V2500-A5/D5 SERIES PROPULSION SYSTEMS SERVICE BULLETIN

V2500-ENG-73-0215

ENGINE – FUEL METERING UNIT (FMU) – TURBINE OVER SPEED VALVE – INTRODUCTION OF A
MODIFIED ELECTRO-HYDRAULIC SERVO VALVE COMPARTMENT HEAT SHIELD

ENGINE FUEL AND CONTROL - FUEL METERING UNIT (FMU) - Incorporation of Electrical Cover

Cover Interference Marks
(Sheet 1 of 1)

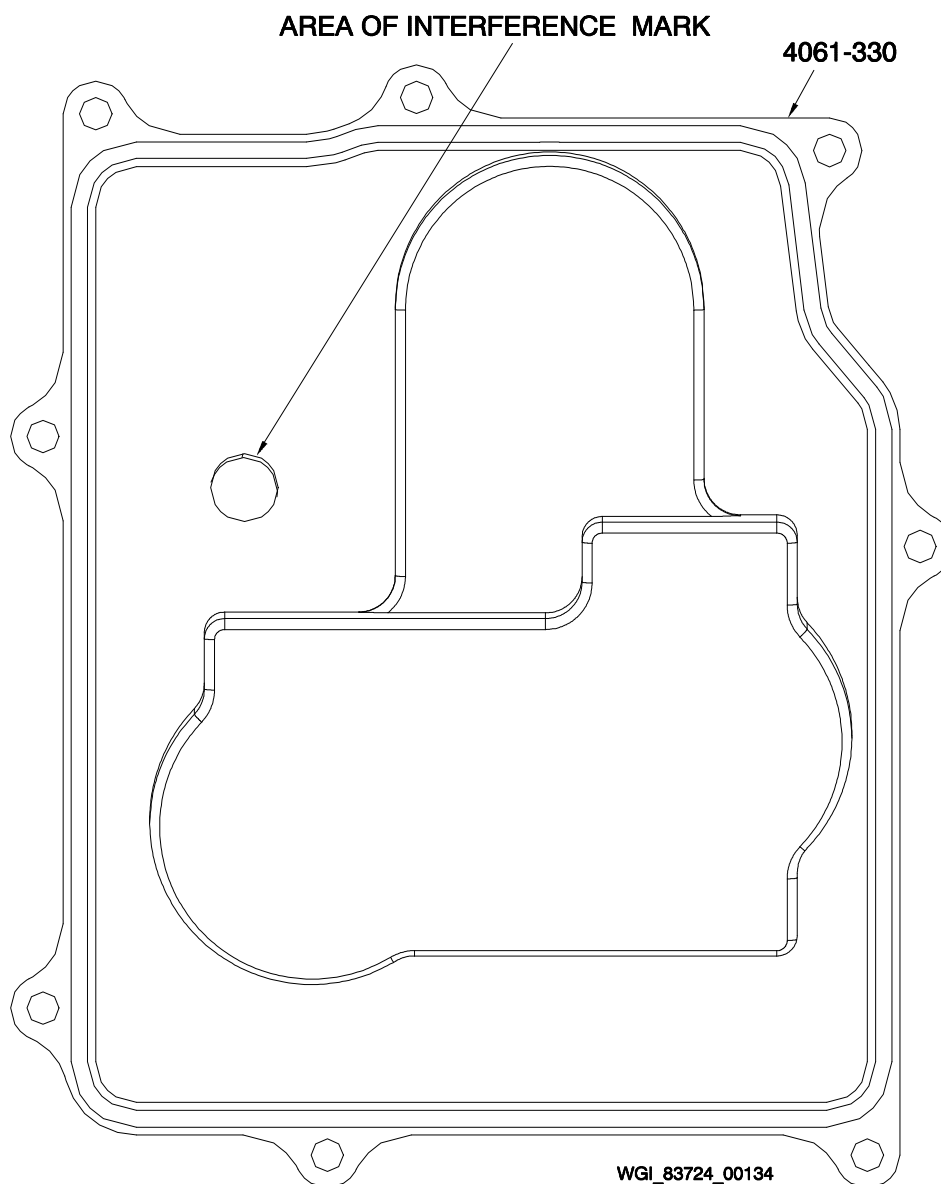
Cause: Interference between the overspeed valve switch activation rod and the electrical cover (4061-330) results in cracking and separation of the switch rod head from the body. The separation of the head on the switch rod prevents switch activation which results in an EEC fault. Except for the switch indication, no other overspeed functions are affected.

Improvement: A new electrical cover (3550-1563) has been released and includes a new raised feature above the switch activation rod to alleviate all interference potential.

- (1) Remove electrical cover P/N 4061-330, as specified in CMM 73-28-06, to gain access to the overspeed valve switch activation rod P/N 3100-1025.
 - (2) Check cover for marks associated with rod and cover interference similar to figure below (see Figure below).
- If interference exists, continue to step 3.
 - If interference does not exist, continue to step 8.

- (3) Remove the overspeed valve switch activation rod P/N 3100-1025 and discard.
- (4) Disassemble the FMU to gain access to the overspeed valve dry drain seals P/N 1391-332 (quantity 2) and P/N 182658 (quantity 2).

- (5) Remove and discard the overspeed valve dry drain seals P/N 1391-332 (quantity 2) and P/N 182658 (quantity 2).
- (6) Install replacement overspeed valve dry drain seals P/N 1391-332 (quantity 2) and P/N 182658 (quantity 2).
- (7) Install replacement overspeed valve switch activation rod P/N 3100-1025.
- (8) Install replacement cover packing P/N 1355-794 and new electrical cover P/N 3550-1563.
- (9) Discard old cover P/N 4061-330 and cover packing P/N 1355-796.
- (10) Finish assemble the FMU.
- (11) Test the FMU as specified in TESTING AND FAULT ISOLATION.
- (12) Mark the Service Bulletin dataplate 73-0215.
